DEVELOPMENT FACILITATION TEAM (DFT) MEETING AGENDA

REQUEST: Sketch plat review of Phase 1 Salazar Lands Subdivision

Re: PHASE 1 Salazar Lands Subdivision- Sketch Plat Submittal

PHASE 1 SITE PLAN EXHIBIT

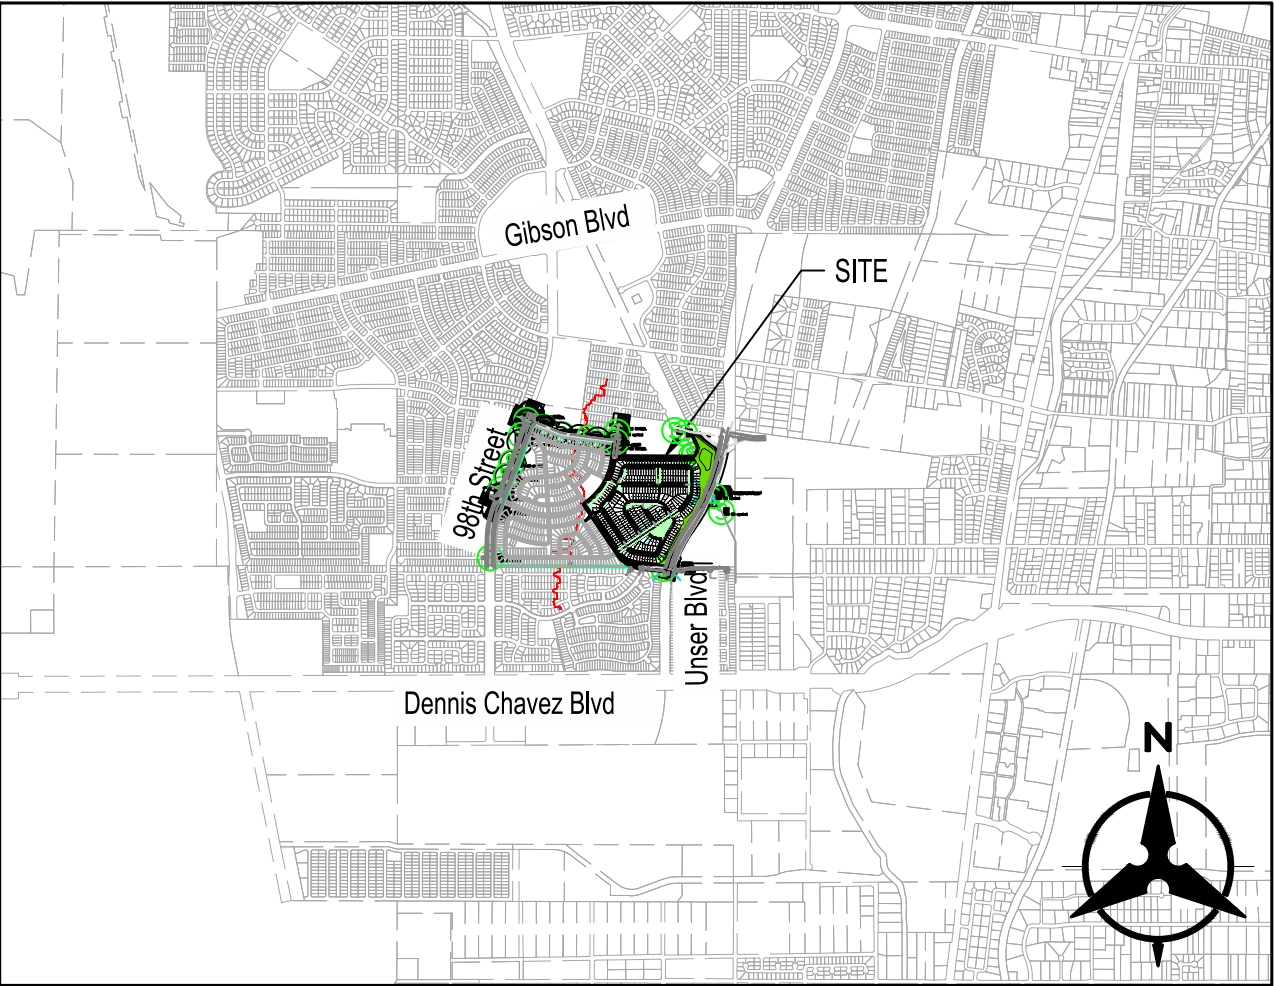
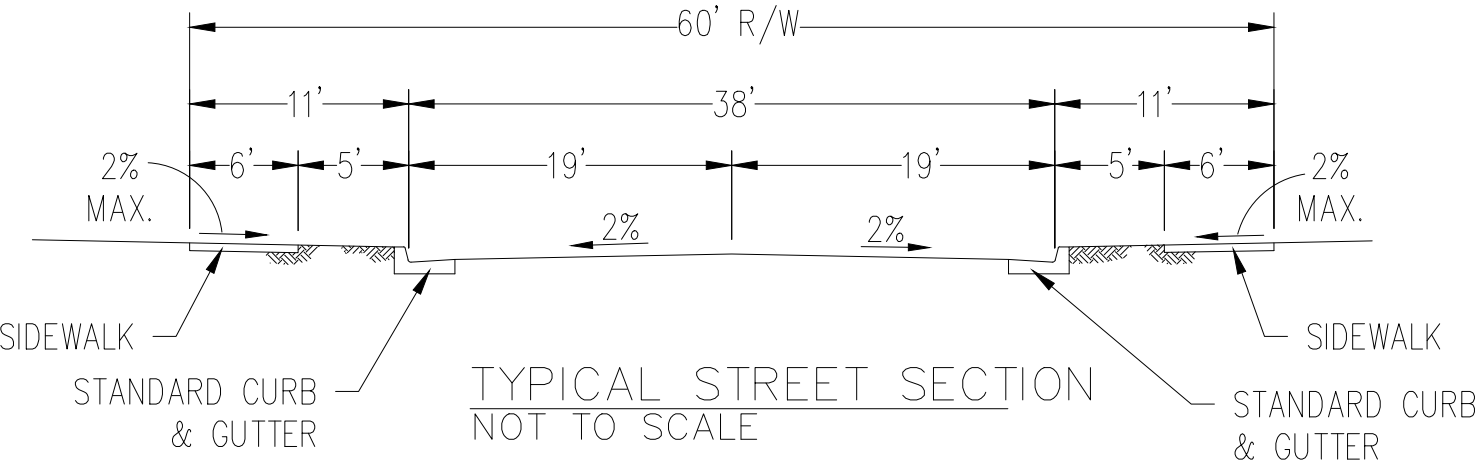
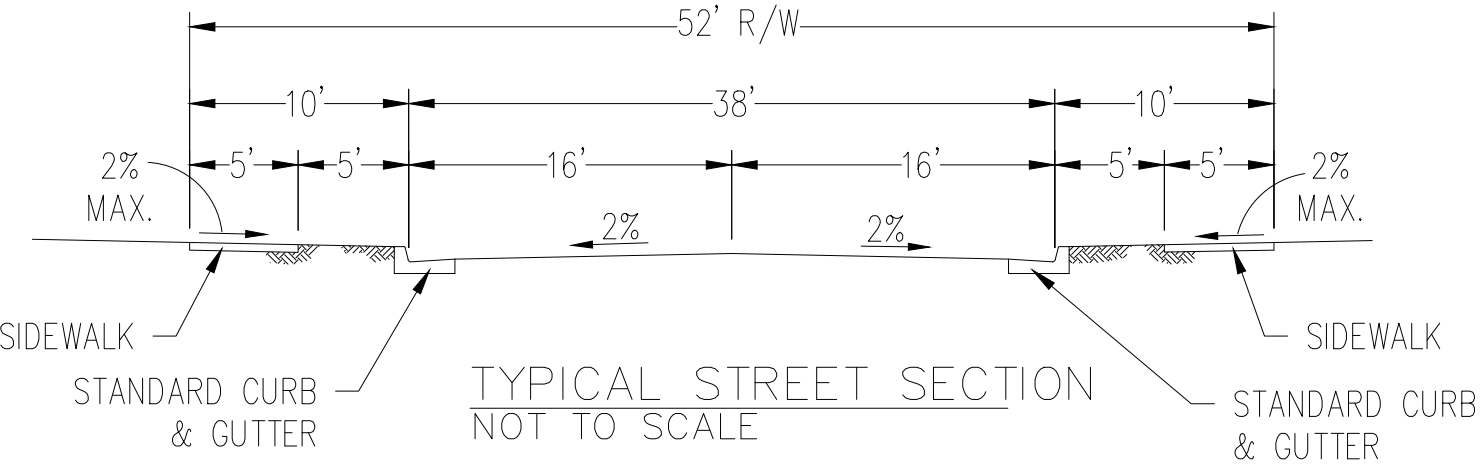
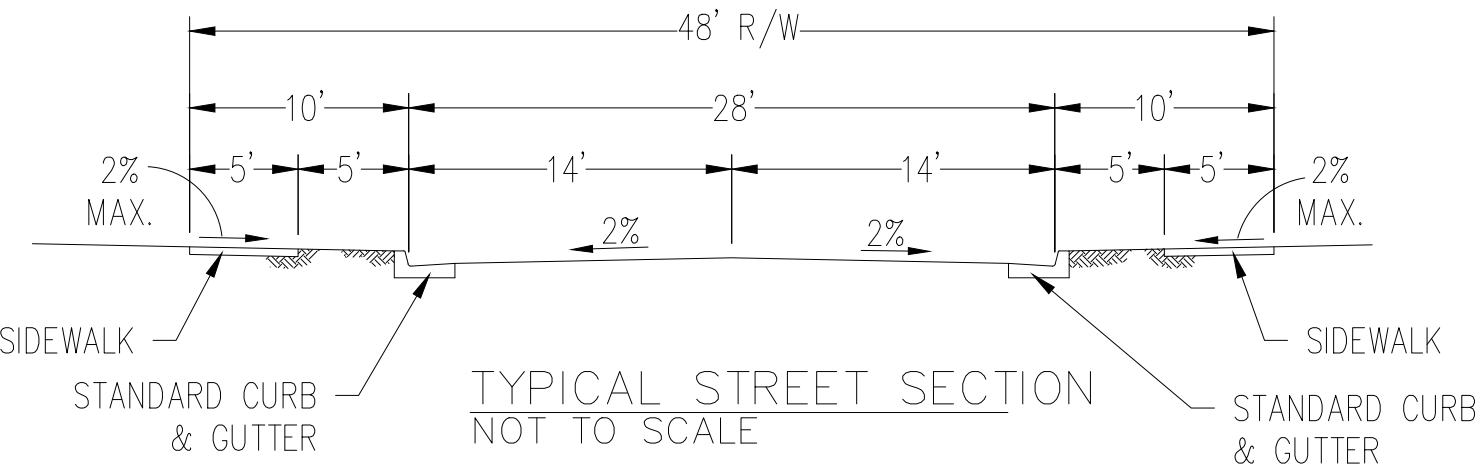
1. Will there be any necessary improvements or modifications to Unser Blvd to accommodate the new subdivision, especially at the points of ingress and egress?
2. Are there any required infrastructure improvements along Anderson Hill Ave, Vermejo Park Dr, or Unser Blvd?
3. Is this portion of Unser Blvd owned and maintained by the NMDOT or the COA?
4. We are aware there is an AMAFCA drainage ROW and FEMA floodplains on the site. We have coordinated with AFMFCA and vacated the portion of ROW through

CONCEPTUAL UTILITIES EXHIBIT

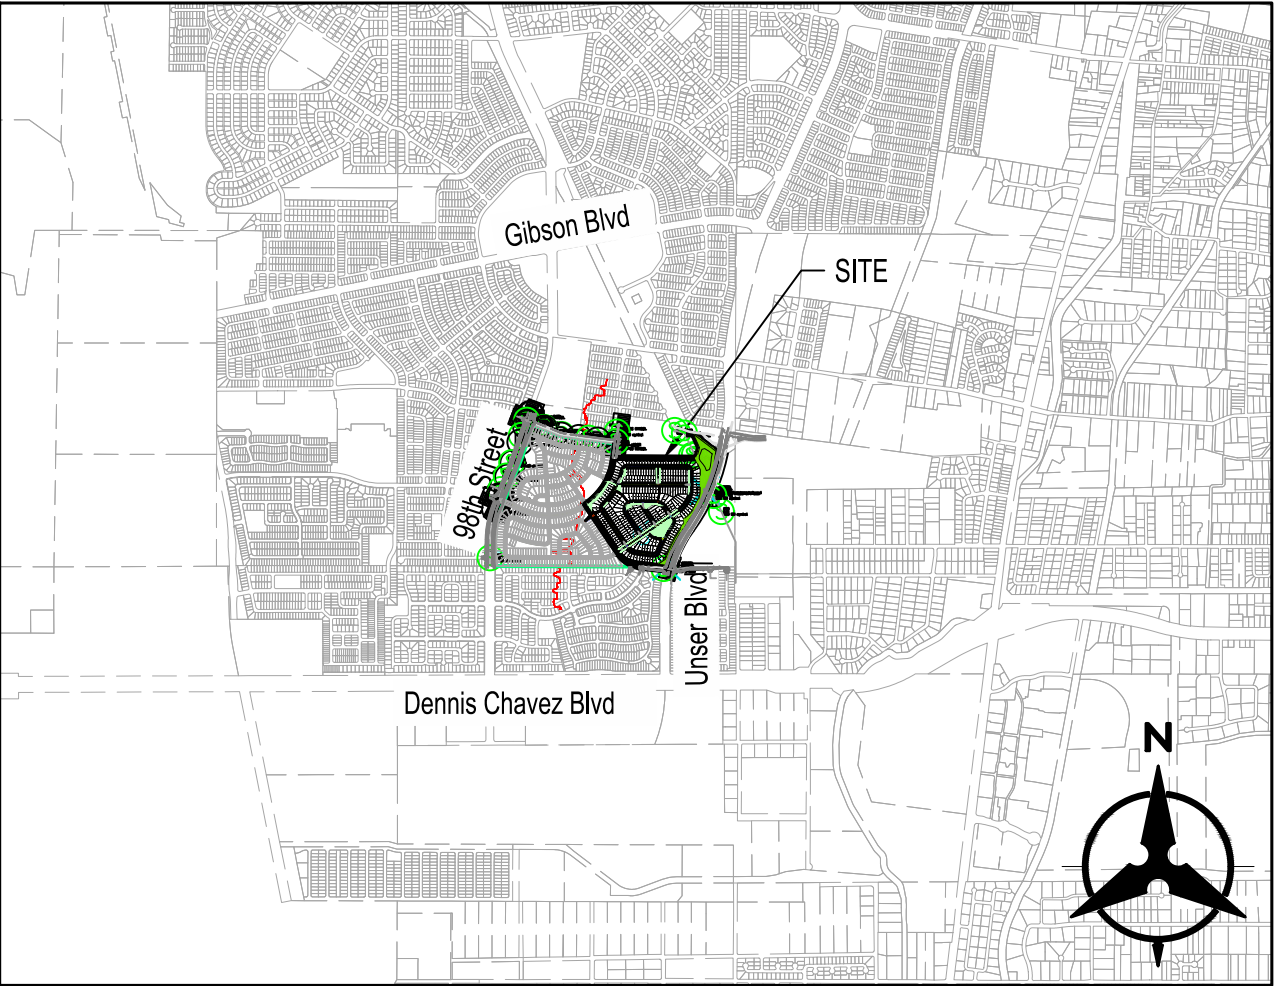
5. We are in the process of submitting a Water/Sewer Availability to ABCWUA.
 - a. Overall, the site drains due east towards the Ex 27" SAS line. Additionally, there is an existing 12" SAS line in the southeast corner in Anderson Hills. Are there any stubs located off the 27" SAS line? Will the site otherwise be able to connect to this 27" line and/or will we be able to drainage towards the 12" line in Anderson Hills.

- b. The site is also located in two pressure zones (2WR and 1WR). For Phase 1, pending final grading, it is assumed the site will be serviced by the 1WR water line that can be looped with two connections to the existing 12" WL in Unser. A 2WR waterline will also be constructed for the future phase connections. (With future phases, the 2WR water is assumed to be looped through the 2WR waterline in Unser and the 2WR waterline Amole Mesa/Vermiejo. Will there be a need for a PRV with this development?
